Access Compliance Report Public Rights-of-Way (Pedestrian Signals)

Main Street: **DANA_POINT_HARBOR_DR** Cross Street: **CASITAS_PL** Location: **SE**

ADA ID: **SGRK220208170611** Signal Type: **One Push Button-Non APS** Overall Compliance: **No** Severity Scores: **BTN 1: 35** **BTN 2: N/A** **No BTN: N/A**

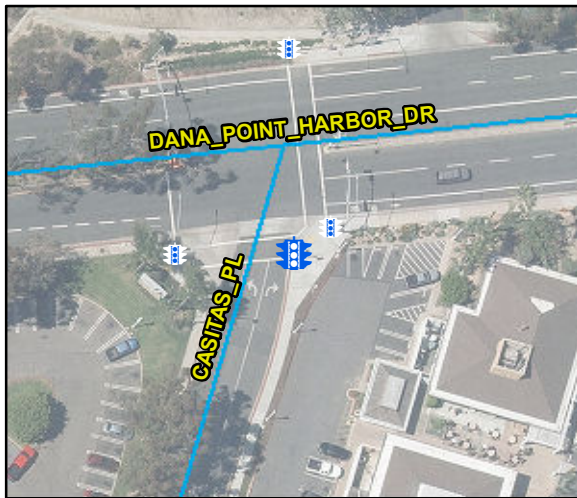
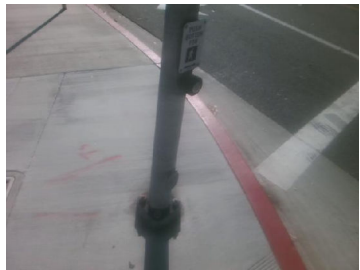
Possible Solutions: Replace Signal Push Button With APS Button. Remove and Replace Clear Space.

OC Std/PROW: **R404.2, MUTCD 4e.08**
